## **ATTACHMENT J**

### **Comments from Other Stakeholders**

Re: ACCCE Comments on “Public Health Benefits of Reducing Ground-Level Ozone and Fine Particulate Matter in the Northeastern U.S.”

Reliant Energy, Inc. and our contractor ENSR Corporation appreciate the opportunity to comment on the draft MANE-VU report entitled "MANE-VU Modeling for Reasonable Progress Goals – Model Performance Evaluation, Pollution Apportionment and Control Measure Benefits" as prepared by Northeast States Coordinated Air Use Management (NESCAUM). Reliant Energy owns and/or operates many power plants in the United States including 18 in the Commonwealth of Pennsylvania and four in the State of New Jersey, and we are dedicated to operating all of our plants in compliance with all applicable environmental regulations and permits. We take seriously our responsibility for environment stewardship and exercise care for the communities that we are members of and serve. Details of Reliant Energy's comments to the aforementioned report are provided in the attached document – our comments can be summarized as follows:

### Modeled PM<sub>2.5</sub> Impacts from MRPO CAIR-Plus Strategies with Interstate Emissions Trading

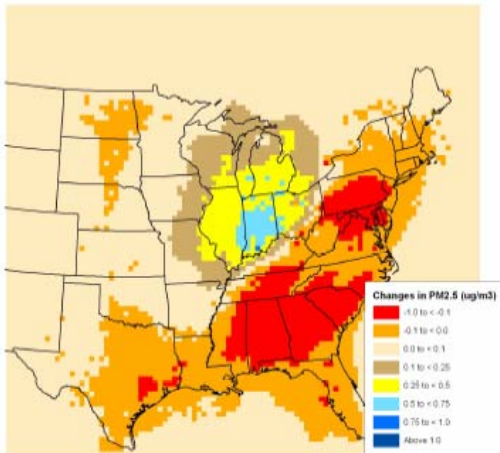
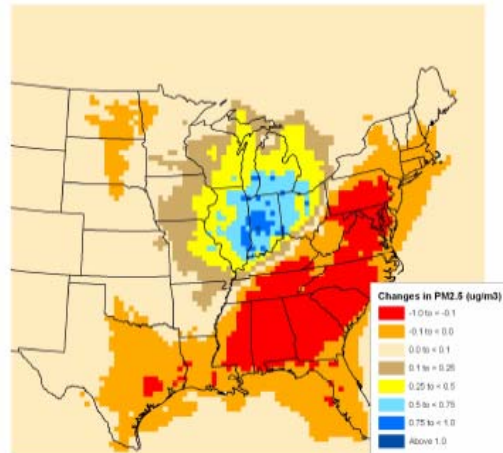
Stratus' findings for MRPO, summarized in the IPM cases modeled below, indicate that the potential downwind impacts of emissions "leakage" from the MRPO region largely offset the benefits of controls imposed within the MRPO. When unrestricted emission trading is permitted, the emission reductions resulting from CAIR-Plus controls within the MRPO region generate tradable allowances that can be sold outside the region. The Stratus analysis illustrates the effects of such trading in states outside the MPRO region, based on IPM modeling of annual PM<sub>2.5</sub> concentrations:

**Figure 1 Composition Plot of Regional Haze at Lye Brook Wilderness Area, 2005**

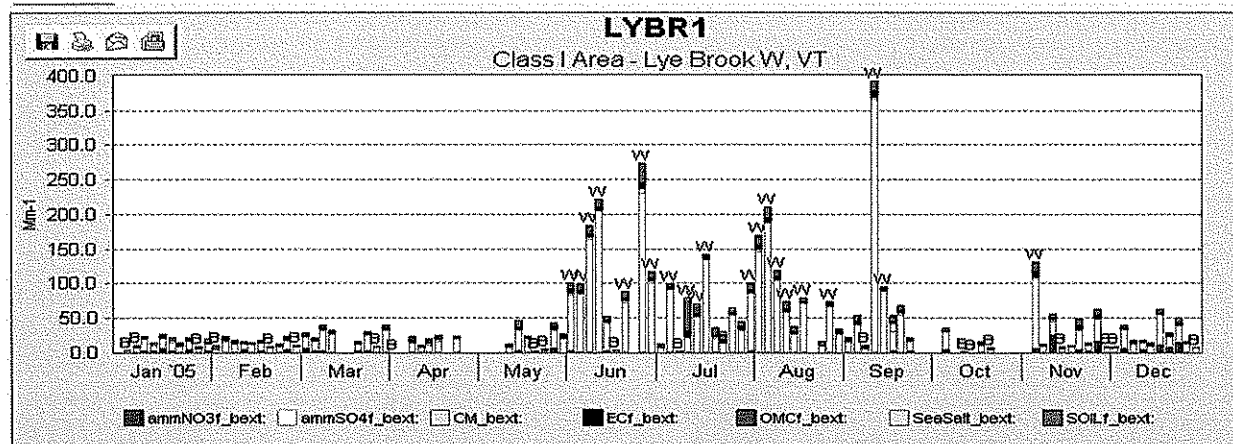
*Comment #1 on Section 2: Poor modeled meteorological performance during the summer period has significant implications for conclusions regarding source attribution for regional haze impacts.*

The meteorological evaluation indicates that the MM5 performance is poorest during summer conditions (June-August), which is a period that corresponds to many of the worst-case regional haze days (as noted from a review of the IMPROVE data from the web site at <http://vista.cira.colostate.edu/views/>). Therefore, attribution of targeted emission sources that may contribute to the worst 20% days (many of which occur in summer; for example, see Figure 1) is uncertain due to the poor modeled meteorological performance (particularly with regards to the trajectory analysis). It should also be noted that the modeled meteorological performance was poorest for the southern U.S. and interior portions of the U.S. East Coast (NESCAUM states) as compared with other areas included in the model domain. This may have consequences for the accuracy of the efficacy of the BOTW regulations that are advocated by the NESCAUM report.

**Figure 2 PM<sub>2.5</sub> Sulfate Performance Plot from Draft MANE-VU Report**

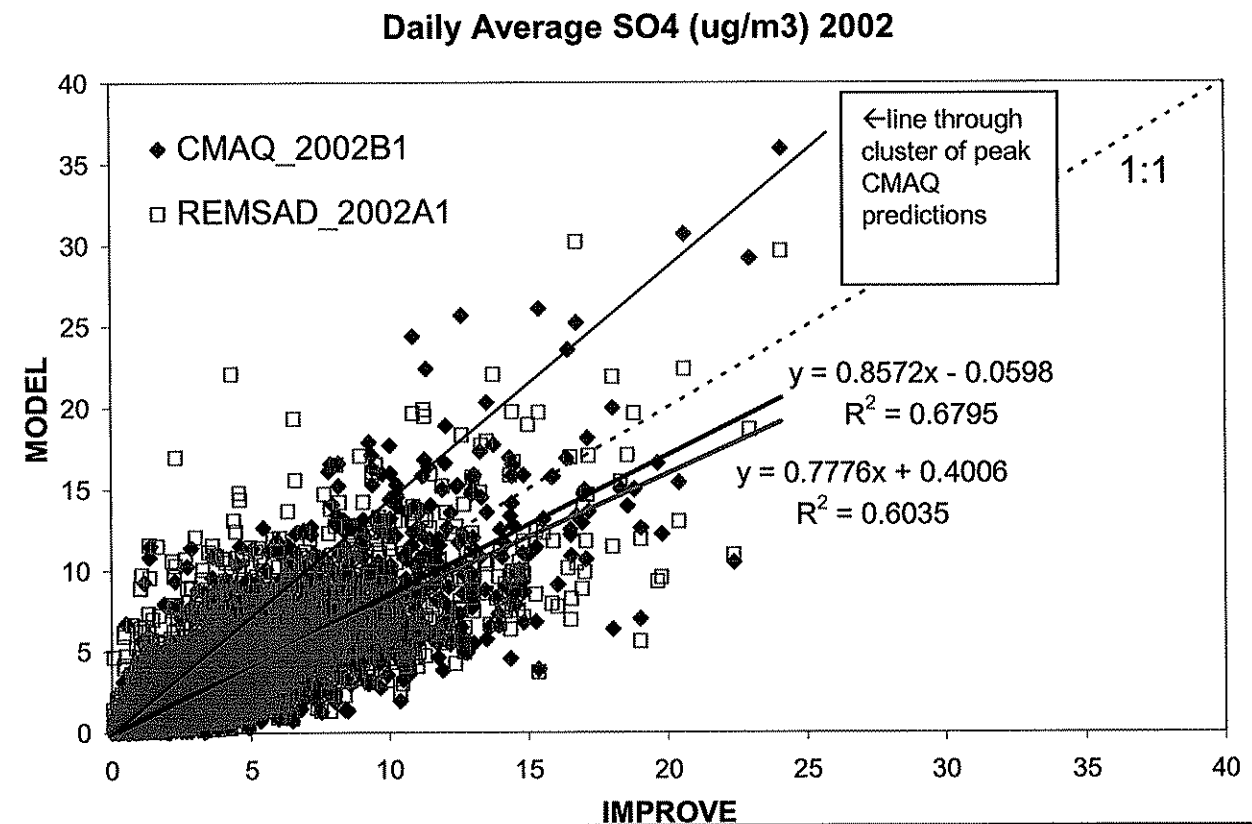
*Comment #3 on Section 2: The regression lines and slopes attributed to the model performance plots do not match the peak prediction areas in some cases.*

Some of the figures presented in the report (components of Figure 2-11 and Figure 2-16) have best fit lines drawn in the figures that do not appear to match the line one would eyeball that would pass through the peak values. Since the peak values are most important in determining the trend of the worst 20% regional haze days, it makes sense to reconsider the best-fit lines for this purpose. For example, Figure 2 shows the sulfate particulate predictions vs. observations from the report’s Figure 2-11. The blue best fit line far from the area of peak predictions, which are better matched by an alternative line added to Figure 2.

**Figure 3 PM<sub>2.5</sub> Elemental Carbon Performance Plot from Draft MANE-VU Report**

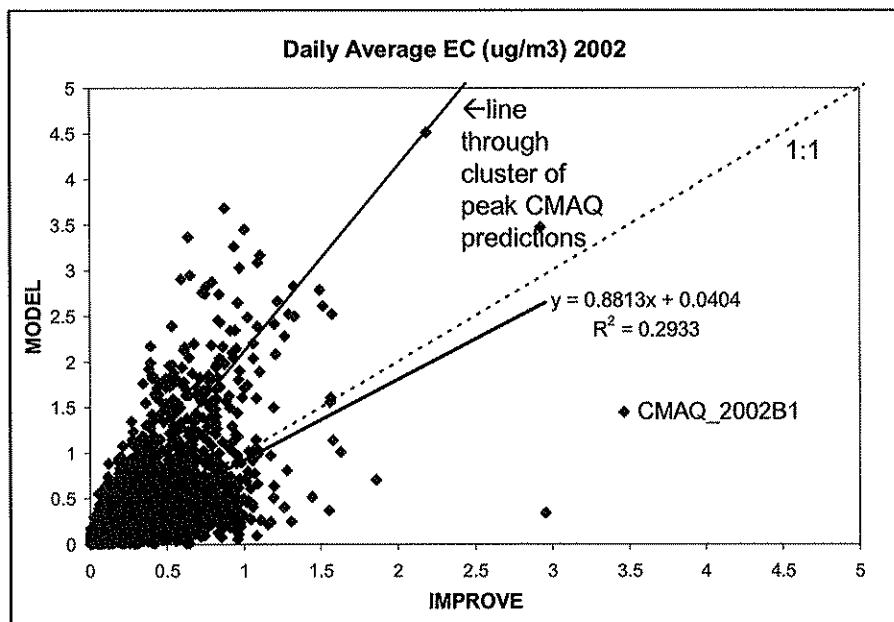
Similar eyeballed best-fit lines through the peak CMAQ predictions are added to Figures 3 and 4. These alternative slopes lead to conclusions that the CMAQ model's peak predictions are too high (i.e., the model is over-responding, especially on the worst 20% regional haze days), and can result in a conclusion that certain emission components have an exaggerated effect on visibility.
